**HEARING REPORT**

**PRIVATE PLAN CHANGE 100 - RIVERHEAD**

**RIVERHEAD LANDOWNER GROUP**

**Figure 11:** IX.10.2 Riverhead: Precinct plan 2 area (orange) and the three park locations

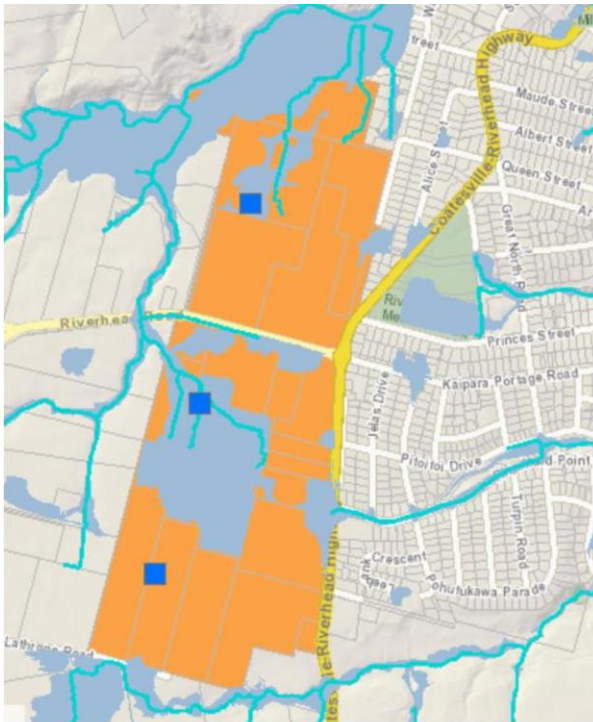
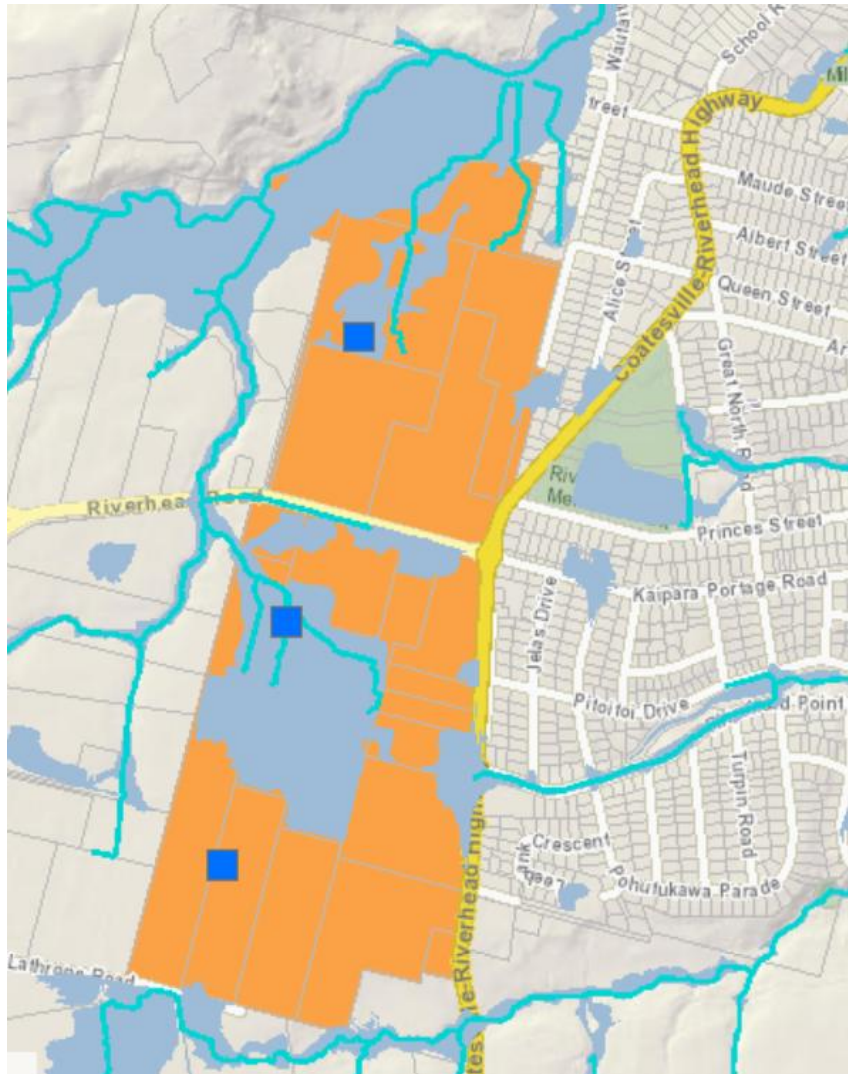
**B4. Te tiaki taonga tuku iho - Natural heritage**

- Since the recent Auckland flood event(s) two of the indicative park locations that were outside flood plain(s) when the area was originally assessed are now within flood plain(s) as noted in **Figure 11** above, so would not be suitable for parks unless the flood plains were managed to prevent flooding of the parks.

*IX.10.2 Riverhead: Precinct plan 2 – Structural Elements is to be amended to delete the three proposed neighbourhood parks (indicative locations) and amend by illustrating the proposed locations of two neighbourhood parks as shown in **Figure 14** above. The legend, in relation to the neighbourhood parks, is to be amended as follows: Proposed neighbourhood park locations (having a minimum area of 5000m<sup>2</sup> each).*

**Figure 13:** ‘Pedestrian shed’ analysis best locations for two additional parks for PC100 precinct plan purposes with multi-purpose green corridor (Source: Rahman Bashir – Principal Property Provision Specialist)

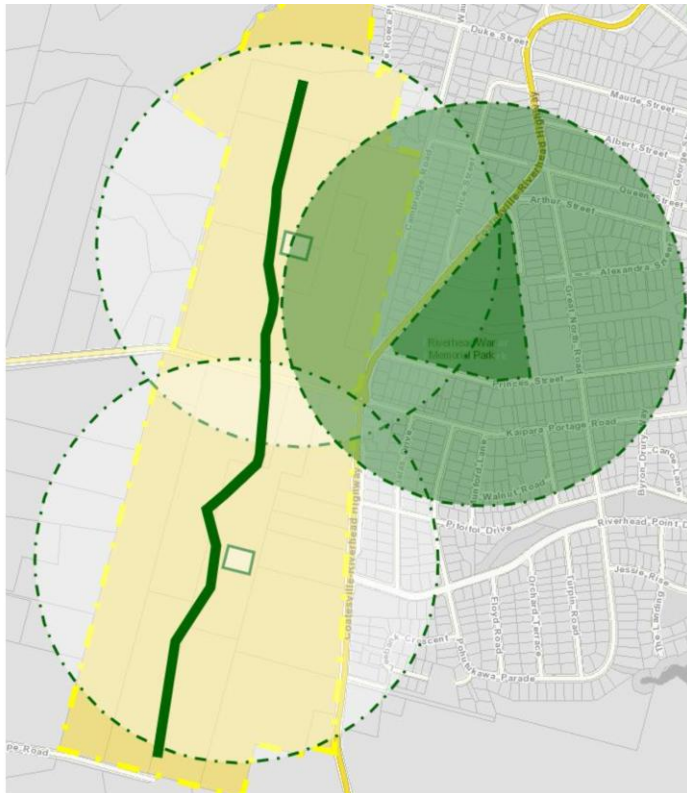
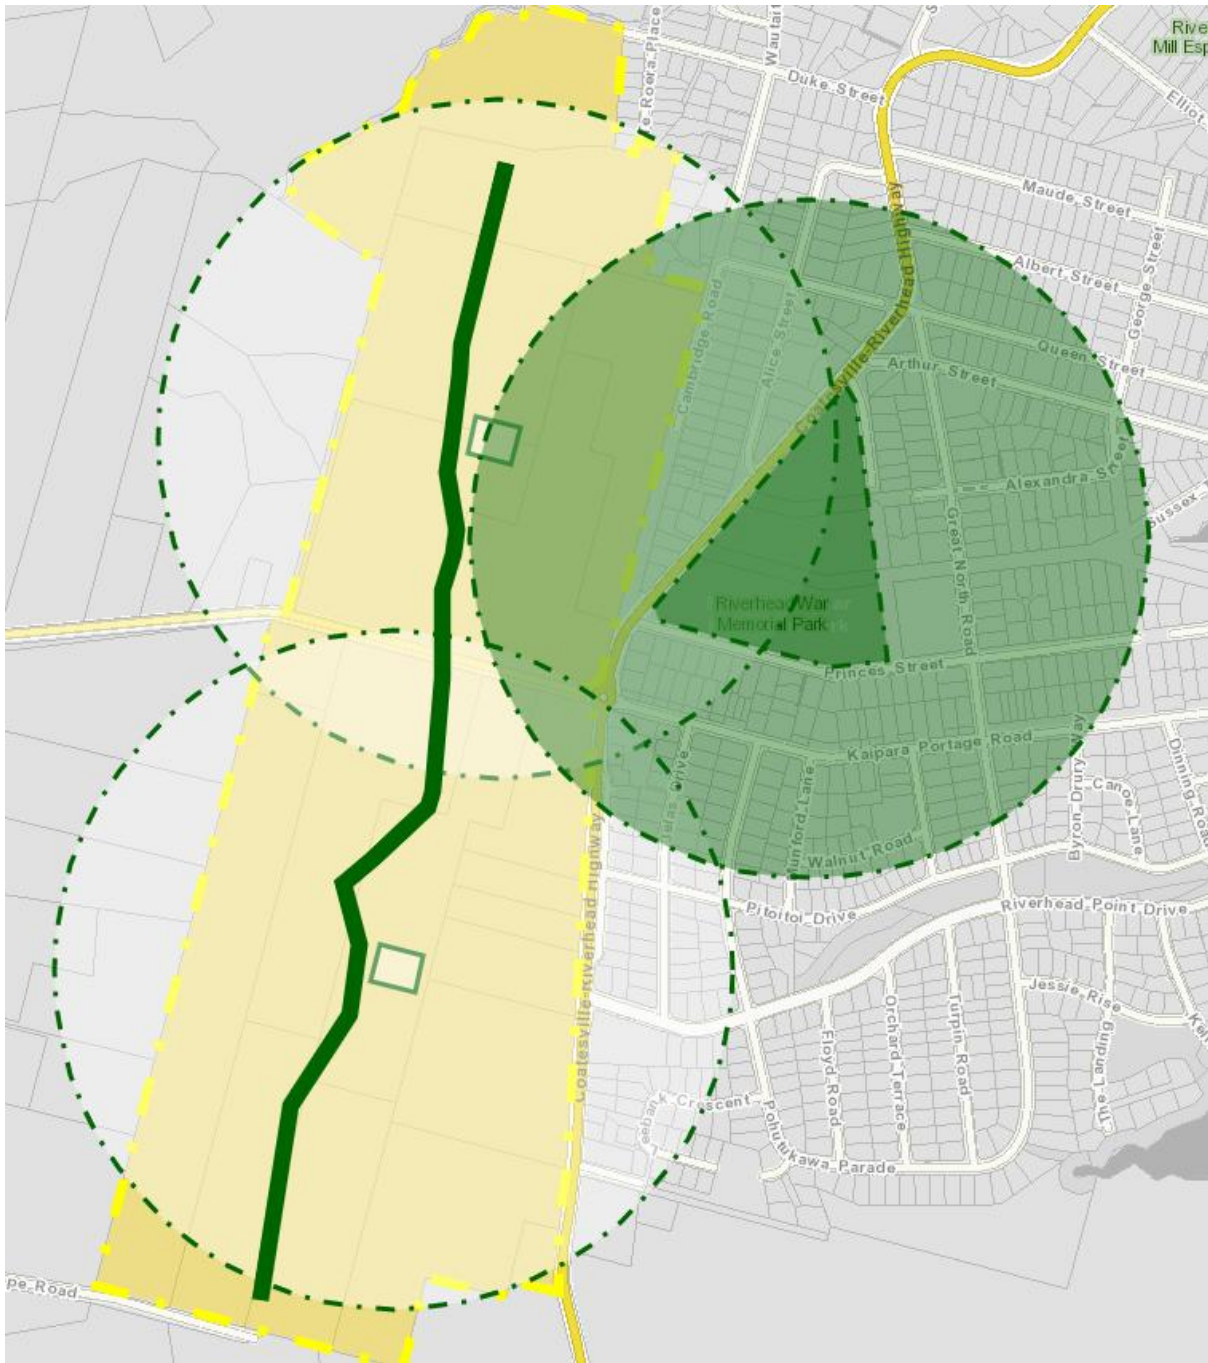
138. Chapter B4 of the AUP sets out the strategic framework for natural heritage resources. Section B4.2 sets out the strategic framework for outstanding natural features and landscapes.

- o See **Figure 13** below for a second graphic illustration of the two indicative park locations, the Riverhead Memorial Park, and the improbable multi-purpose green corridor, as they could be illustrated in an amended PC100 precinct plan.

Delete the three proposed neighbourhood parks (indicative locations) and amend by illustrating the proposed locations of two neighbourhood parks as shown in **Figure 14 of parks memo**

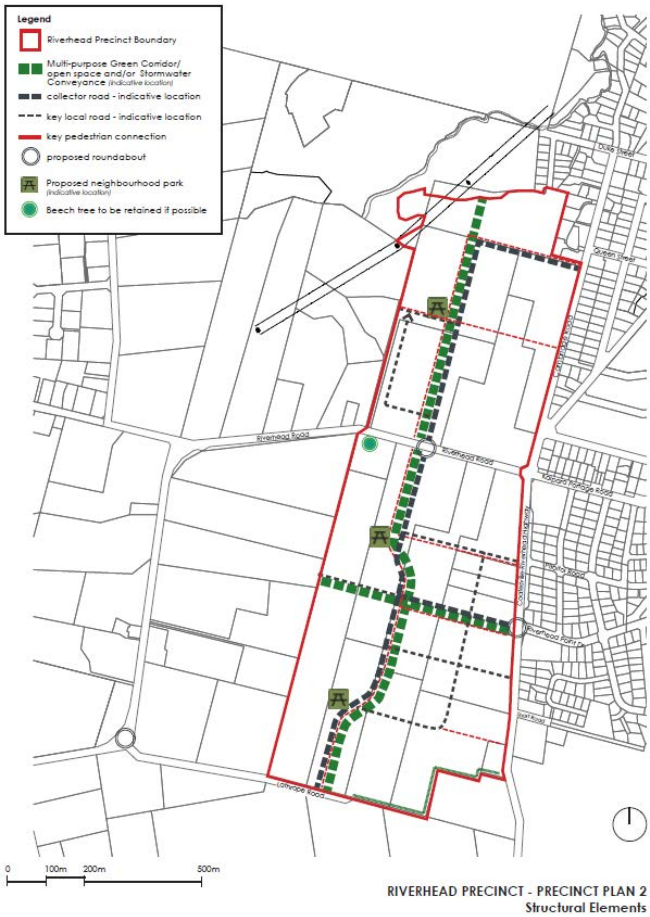
Add two additional direct east to west pedestrian connections towards the Riverhead Memorial Park on that part of the PC100 map area north of Riverhead Road

Figure C: Potential increase of floodplain extent (shown in green) between the pre and post development scenarios for the 1% AEP event without the climate change factor.

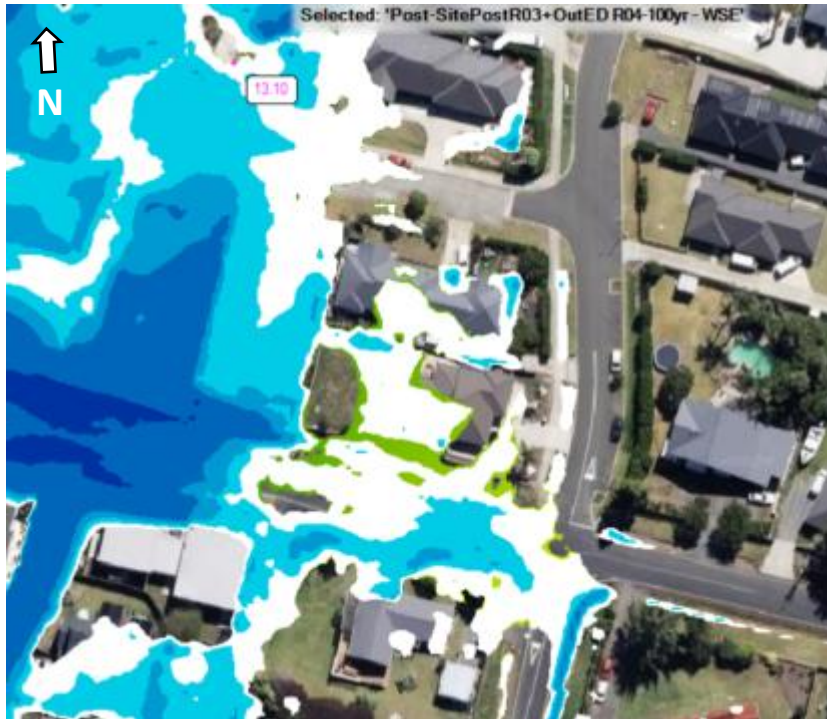
<sup>3</sup> Rev 02, prepare by CKL, dated 08/12/2022, in Appendix 3 attached to the CKL report.

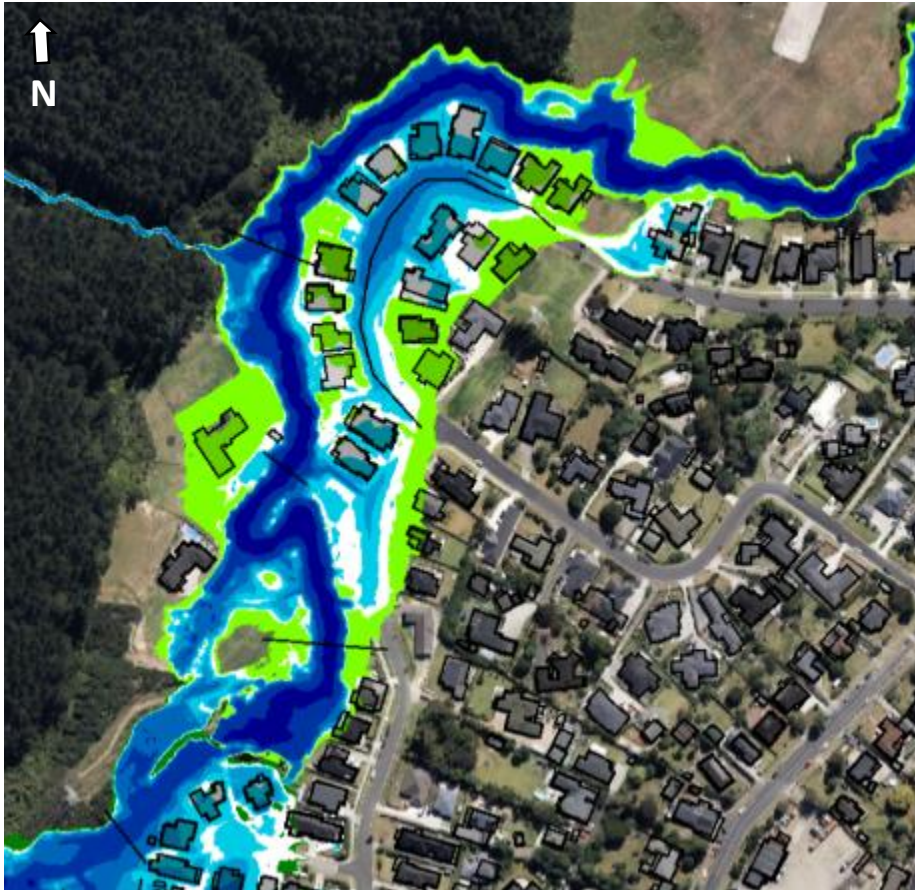
25. The 3.8°C climate change factor allows for the prediction of future flooding risks in hydraulic models by including climate-driven changes in rainfall, runoff, and flood levels resulting from future temperature rises over the next 100 years. Ms Li considers that the 3.8°C climate change factor is the appropriate factor for assessing effects of climate change in relation to flooding risks as per the Auckland Council Stormwater Code of Practice (SWCoP).

Figure F: Floodplain extent with flood hazard categorisation based on the Healthy Waters Regionwide Model. Location of PPC 100 is circled.

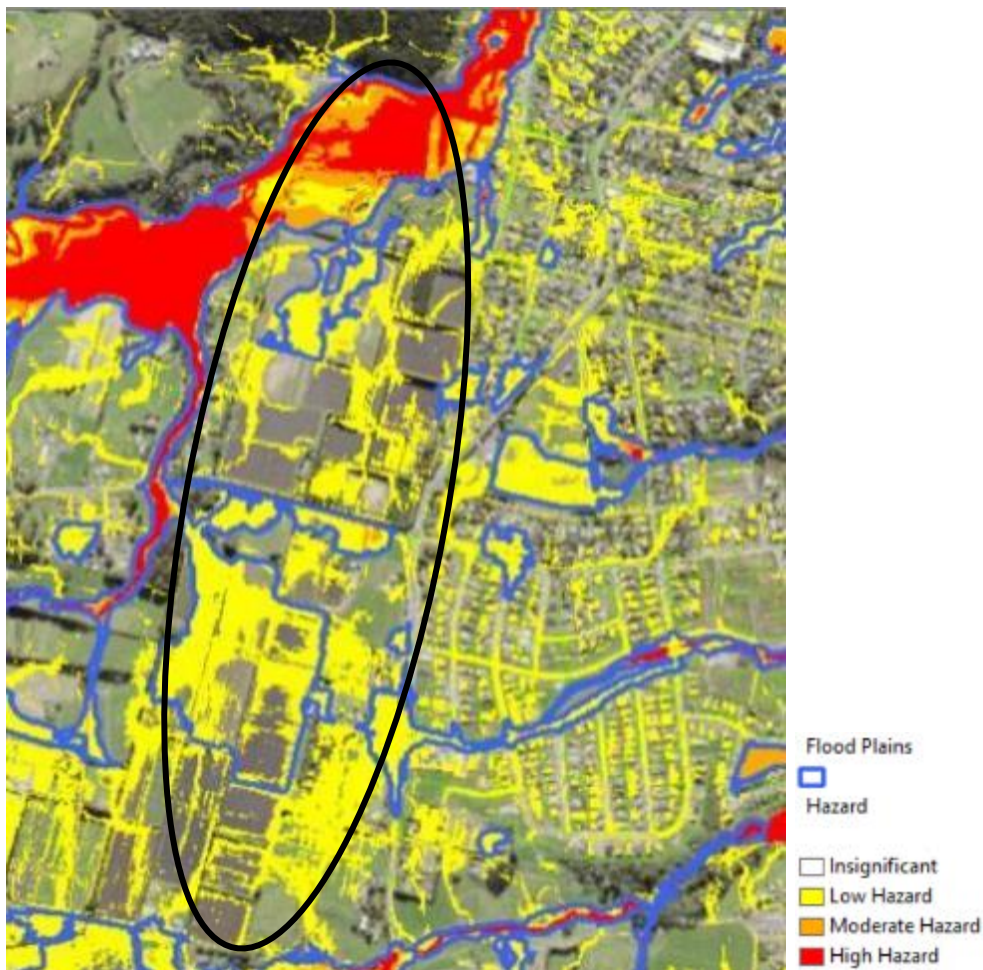
55. Part of the PPC 100 site which has been identified as being subject to moderate and high flood hazard (as per the Healthy Waters Regionwide Model and FDS hazard mapping) is still being proposed to be zoned for urban development (refer to Figures F and G below). Placing urban development in moderate and high flood hazard area will create new flooding risks to people, property and infrastructure if the flooding risks are not appropriately managed. Therefore, we support that the MRZ is being proposed for the northernmost 6ha of the PPC 100 site but recommend the MRZ extent should be increased to 8.5ha, consistent with the floodplain extent and hazard mapping of the Healthy Waters Regionwide Model.
